Re: Submittal of Decommissioning Plan for the Plum Brook Reactor, Revision 5

Enclosed for your information is Revision 5 to the Decommissioning Plan for the Plum Brook Reactor Facility. The revision reflects the revised schedule for completion of the Decommissioning Project that was discussed in our letter of July 11, 2005. In addition, the revision reflects the changes that have occurred as a result of changes in our primary decommissioning contractor organization, and changes in titles in the Glenn Research Center organization.

Revision 5: Revision to reflect the change in schedule that was reported to the NRC and to reflect the revised organization after the departure of the US Army Corps of Engineers and their Total Environmental Restoration Contractor. Changes were made on pages 1-3, 1-24, 1-25, 1-27, 1-28, 2-13, 2-17, 2-42, and pages 2-55 through 2-70

**Figure 2-7 Organizational Structure for the Plum Brook Reactor Facility Decommissioning Project**

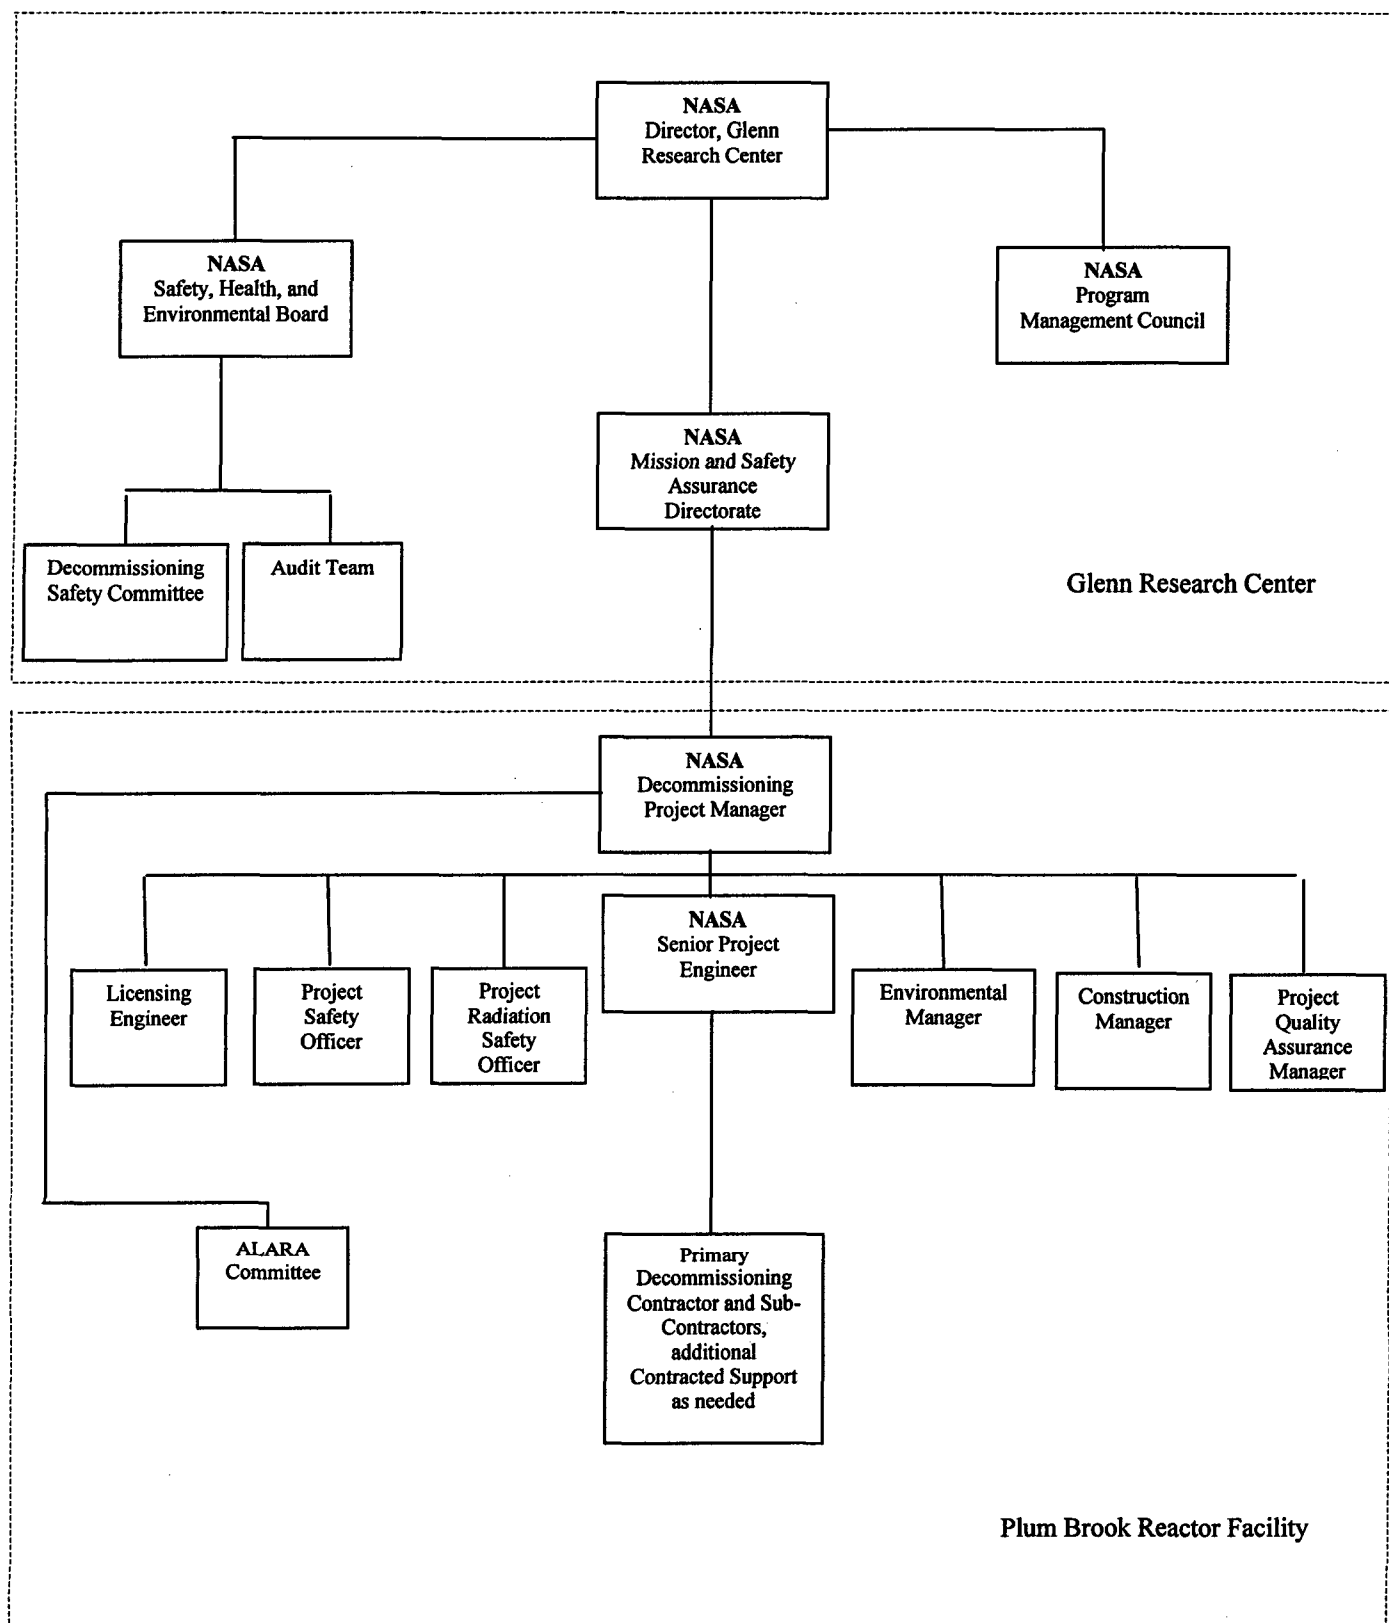
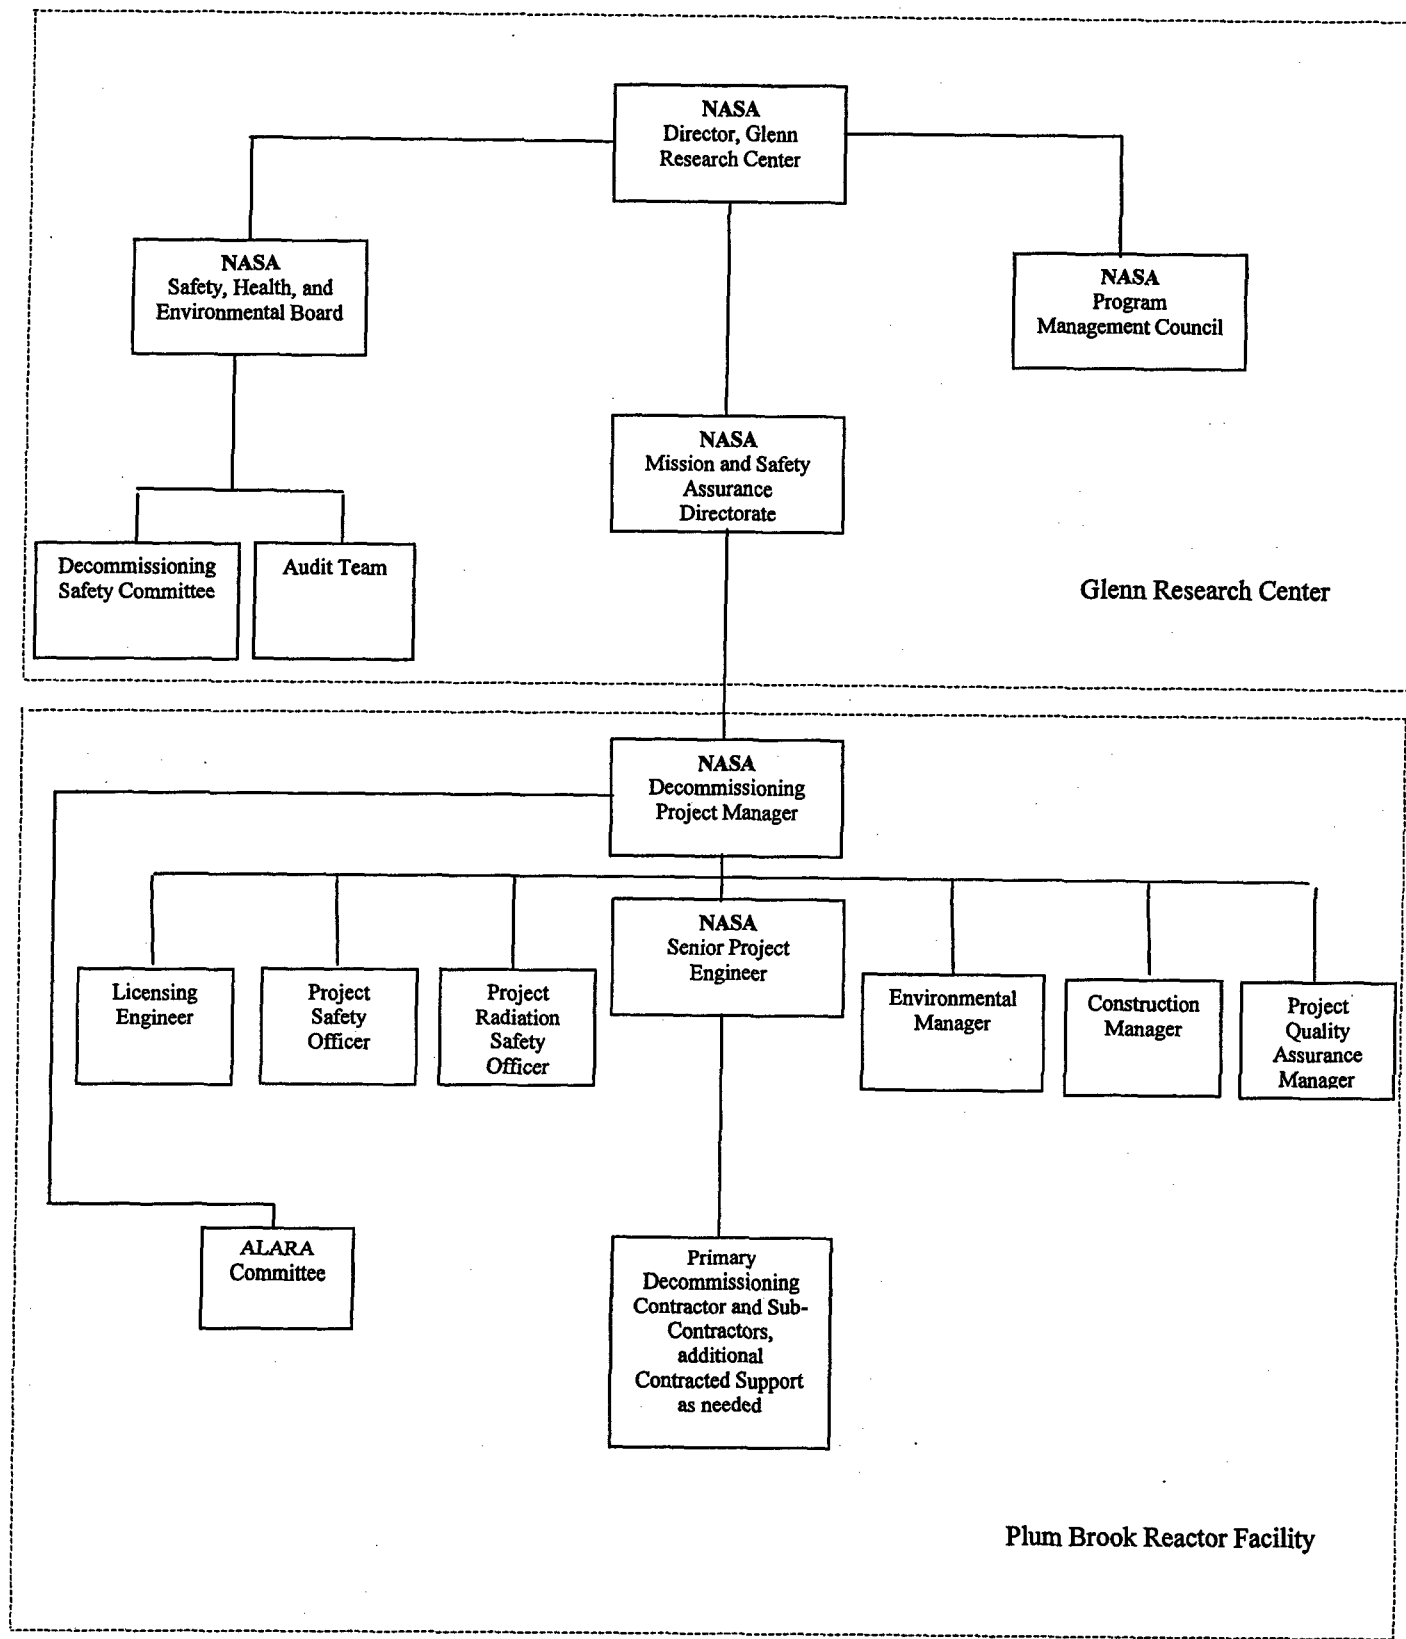
9. Page 2-43- Figure 2-6 was deleted.
10. In section beginning on page 2-55, minor changes were made in the descriptions of key staff positions to clarify the NASA is going to directly manage the day to day to operations and to clarify that single individual may fill multiple positions. On page 2-64, the discussion of the USACE and the TERC onsite organizations were deleted and replaced with a brief description of the decommissioning contractor responsibilities that will be assigned and supervised by NASA. Pages 2-43 through 2-70 are replaced with renumbered pages due to the deletion of the previous contractor discussions. The only substantive changes made on these pages was that title of the "Executive Safety Board" was changed to "Safety, Health, and Environmental Board" on pages 2-65 and 2-68 to reflect a change in the Glenn Research Center organization that combined the functions of the Executive Safety Board and the Environmental Pollution Board into one new board. In addition, the makeup of the Decommissioning Safety Committee was revised by replacing GRC Safety Officer with the Plum Brook Station Safety Officer and by changing the title of the Chief, GRC Environmental Management Office to Safety, Health, and Environmental Division Director to reflect the organizational changes.
